Subject: Response to Request for Additional Information (RAI)  
Regarding the Overall Integrated Plan in Response to  
Order EA-12-051 "Reliable Spent Fuel Pool Instrumentation"

**Fermi 2 NRC Docket No. 50-341  
Operating License No. NPF-43**

**Overall Integrated Plan in Response to Order EA-12-051  
“Reliable Spent Fuel Pool Instrumentation”**

Figure 1:

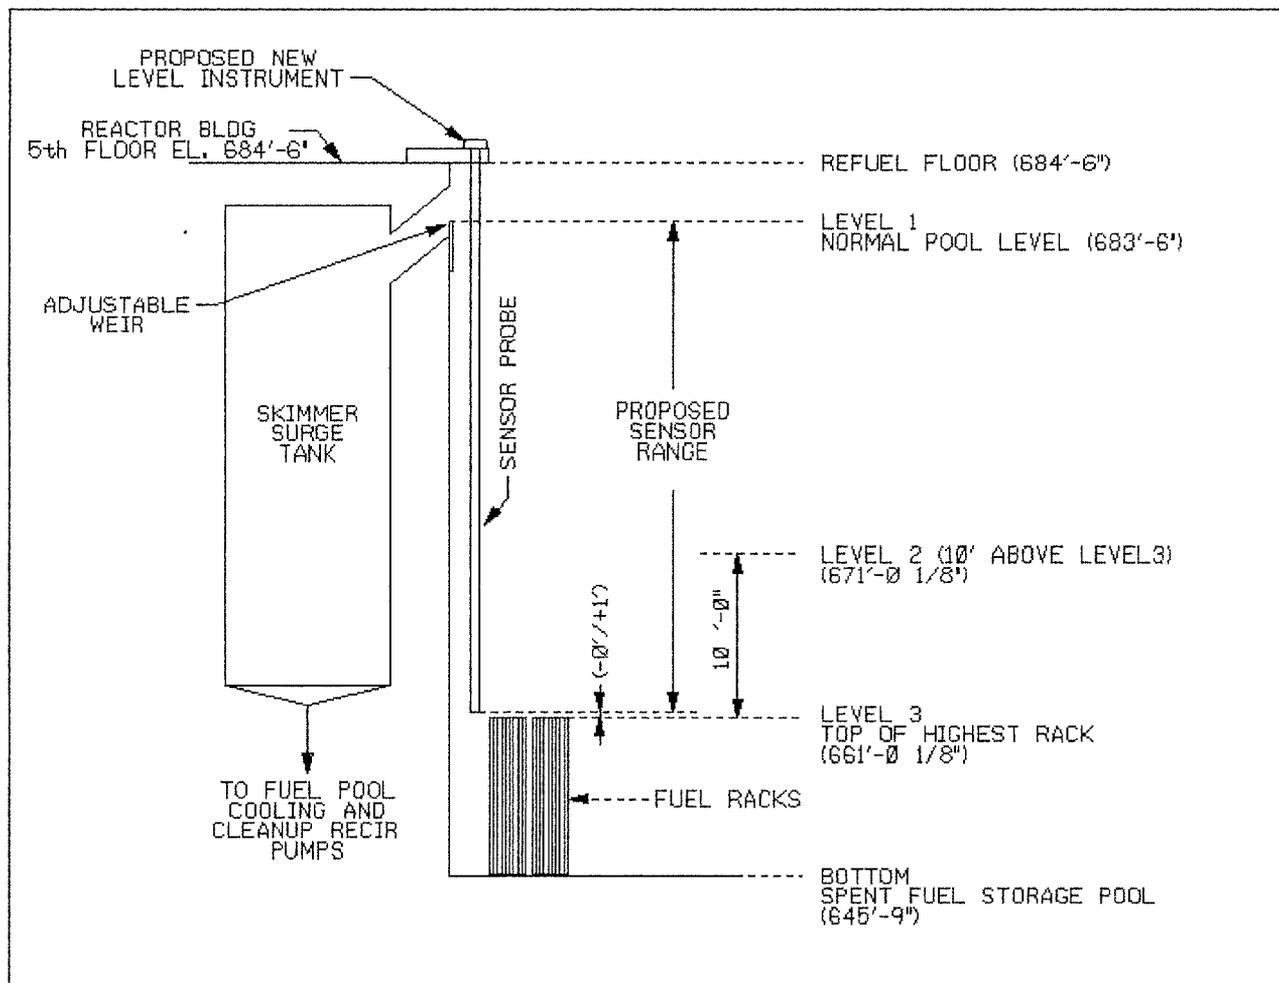
- a) A clearly labeled sketch depicting the elevation view of the proposed typical mounting arrangement for the portions of instrument channel consisting of permanent measurement channel equipment (e.g., fixed level sensors and/or stilling wells, and mounting brackets). Indicate on this sketch the datum values (e.g., 661' 1/8") representing Level 1, Level 2, and Level 3 as well as the top of the fuel racks. Indicate on this sketch the portion of the level sensor measurement range that is sensitive to measurement of the fuel pool level, with respect to the Level 1, Level 2, and Level 3 datum points.

Figure 1 of this enclosure contains the information requested in RAI-1a. Instrument probe mounting details in the Spent Fuel Pool area are provided in the response to RAI-3b.

Level 2 (Elevation 671'-0<sup>1</sup>/<sub>8</sub>"') is established as being ten (10) feet above Level 3 (Elevation 661'-0<sup>1</sup>/<sub>8</sub>"') which is the highest point of any fuel rack seated in the SFP. This is consistent with the guidance of NEI 12-02 where ten feet of water would provide substantial radiation protection from the spent fuel stored in the fuel racks. The radiation from other materials stored in the SFP area may be less shielded if the SFP water level drops down to Level 2. The dose from both the spent fuel in the racks and that from other stored materials will be assessed in a calculation for habitability and equipment qualification as part of the design of the Spent Fuel Pool Level Instrumentation (SFPLI) system. An adjustment to the elevation designated as Level 2 may be necessary to meet the guidance of NEI 12-02.

Figure 2:

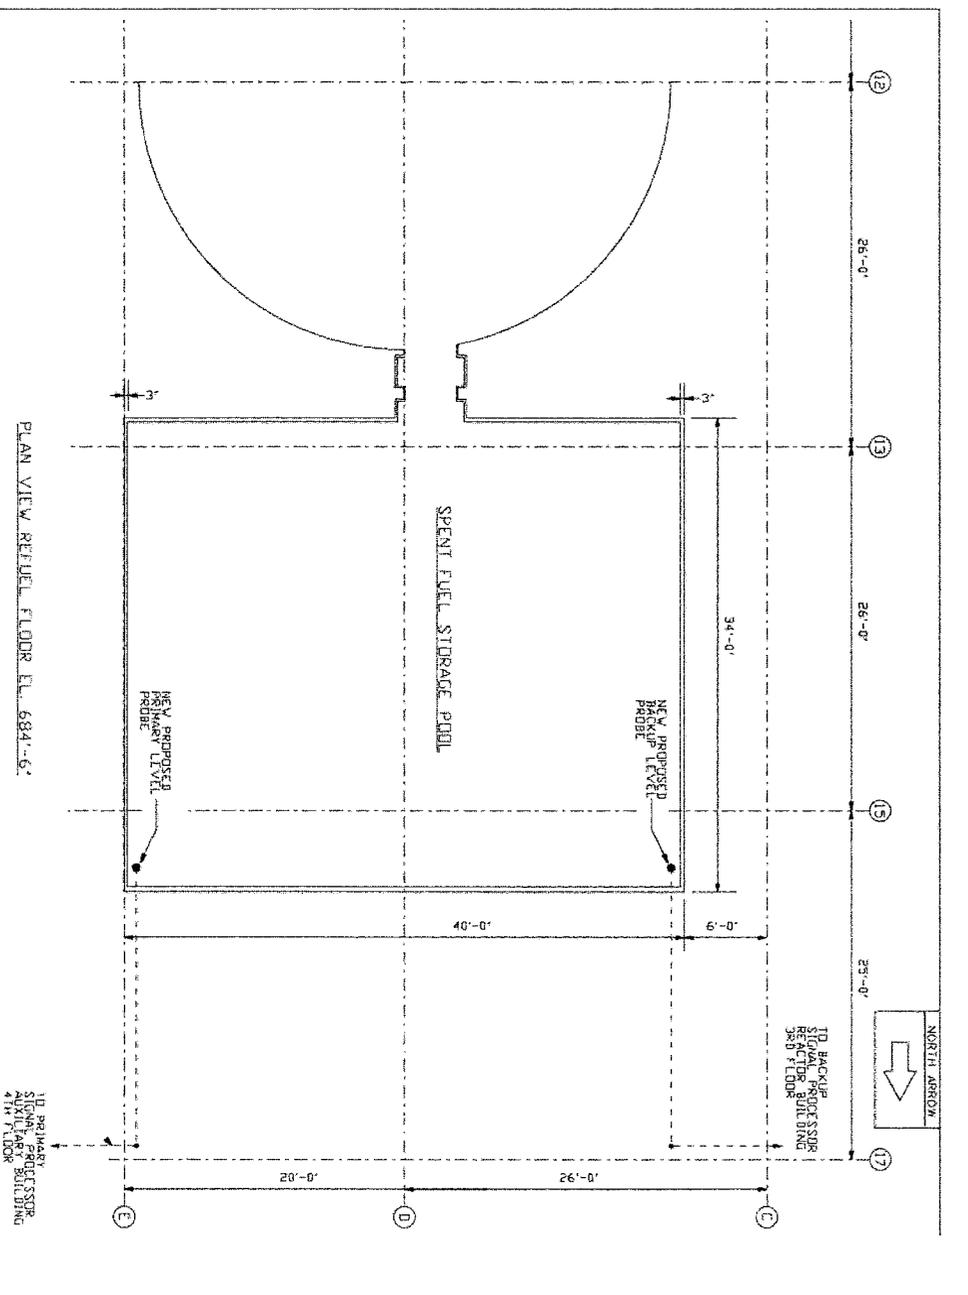
Please provide a clearly labeled sketch or marked-up plant drawing of the plan view of the SFP area, depicting the SFP inside dimensions, the planned locations/ placement of the primary and back-up SFP level sensors, and the proposed routing of the cables that will extend from the sensors toward the location of the local electronics cabinets and read-out/display devices in the main control room or alternate accessible location.

- a) A description of how the two channels of the proposed level measurement system meet the requirement that the potential for a common cause event to adversely affect both channels is minimized to the extent practicable.

Figure 2 of this enclosure contains the information requested in RAI-2.

The primary and backup level sensors are physically separated by the width of the spent fuel pool as shown in Figure 2 of this enclosure. Cabling to the respective signal processors and the associated remote indicators will also be separate due to the separate locations of the backup and primary level indicators as shown in Figures 4 and 5. The primary channel signal processor and the associated remote indicator are located in the Auxiliary Building; whereas the backup channel signal processor and the associated remote indicator are located in the Reactor Building.

The level sensor probes for each channel will be installed on separate corners of the Spent Fuel Pool. The mounts for each level probe will be attached to the concrete floor of Reactor Building (RB) 5<sup>th</sup> floor spent fuel pool area, physically separated from each other (refer to Figure 2). An electronic signal is sent from the sensor electronic panels located on the Auxiliary Building (AB) 4<sup>th</sup> floor and RB 3<sup>rd</sup> floor via separate independent wiring for each channel to the readout display panels located at different locations in the RB 2<sup>nd</sup> floor and in the Main Control Room (See Figures 4 and 5). Independent power sources are addressed in the response to RAI-5a.

Figure 3:

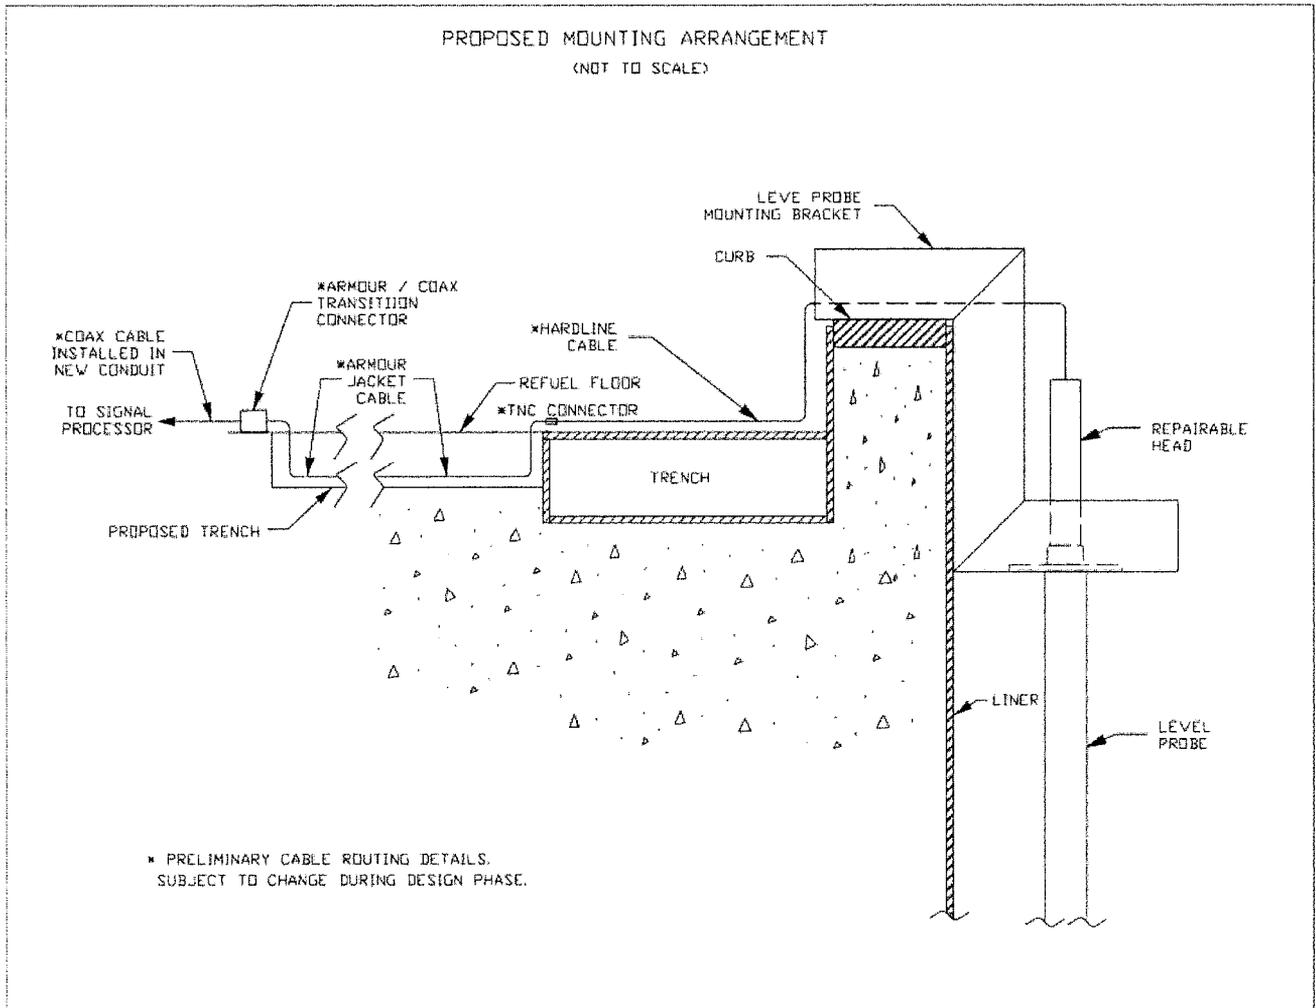
- a) The design criteria that will be used to estimate the total loading on the mounting device(s), including static weight loads and dynamic loads. Describe the methodology that will be used to estimate the total loading, inclusive of design basis maximum seismic loads and the hydrodynamic loads that could result from pool sloshing or other effects that could accompany such seismic forces.

- b) A description of the manner in which the level sensor (and stilling well, if appropriate) will be attached to the refueling floor and/or other support structures for each planned point of attachment of the probe assembly. Indicate in a schematic the portion of the level sensor that will serve as points of attachments for mechanical/mounting or electrical connections.

Figure 3 of this enclosure shows the general mounting arrangement in the SFP area. The level indicator system and sensors that will be mounted at the edge of the SFP are comprised of a level sensor probe assembly, and a mounting bracket. The level sensor probe assembly is placed in the SFP as shown in Figures 1, 2, and 3. The loading on the mounting bracket includes the static weight loads and dynamic loads of the level sensor probe assembly. The dynamic loads consist of design basis maximum seismic loads on the components, along with hydrodynamic loads produced by pool sloshing.

As depicted in Figures 1 and 3 of this enclosure, the level sensor probe is firmly attached to the mounting bracket at the edge of the pool. The probe assembly mounting bolts can be loosened to enable the removal of the probe for repairs, if required. The mounting bracket provides the only mechanical and electrical attachment point for the level sensor probe.

Figure 4:

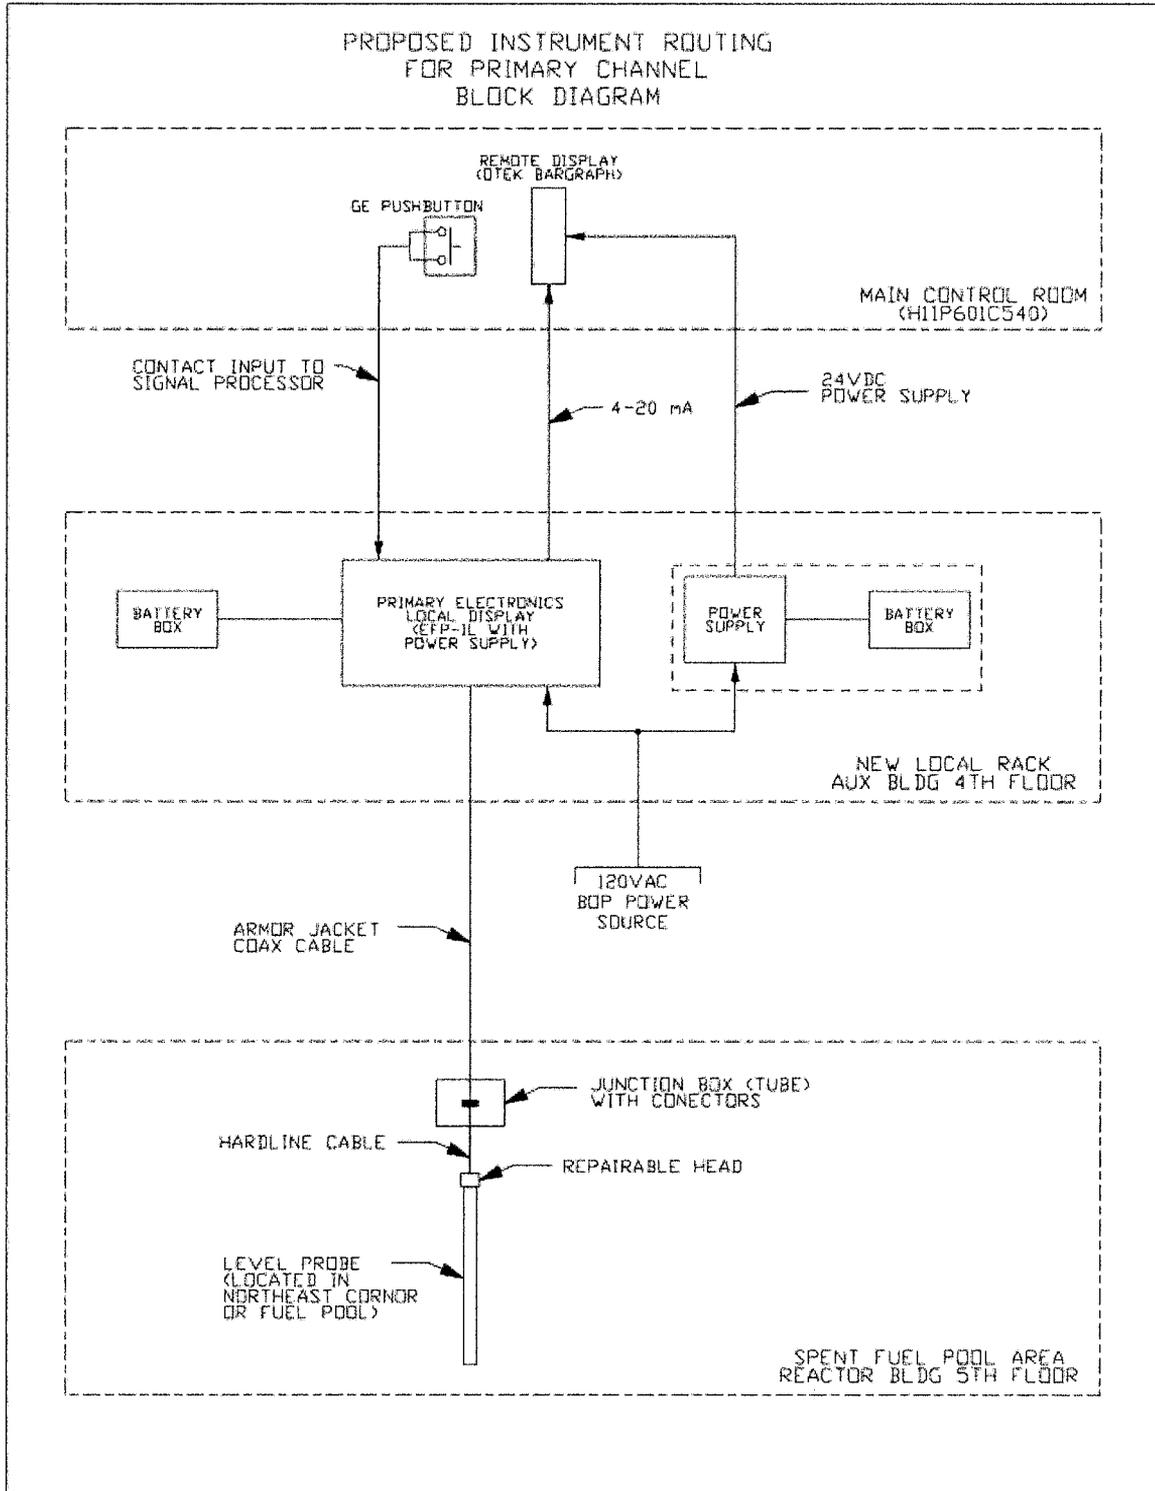
- b) Further information on how each level measurement system, consisting of level sensor electronics, cabling, and readout devices will be designed and installed to address independence through the application and selection of independent power sources, the use of physical and spatial separation, independence of signals sent to the location(s) of the readout devices, and the independence of the displays.

For separation of power to the primary and backup indicators see Figures 4 and 5 of this attachment. The proposed plans call for power to the primary and backup channels using Balance of Plant (BOP) 120 volt AC normal power. The separation of the two channel power sources is discussed in the response to RAI-5b; both power sources are independent such that no one single failure will interrupt power to both channels.
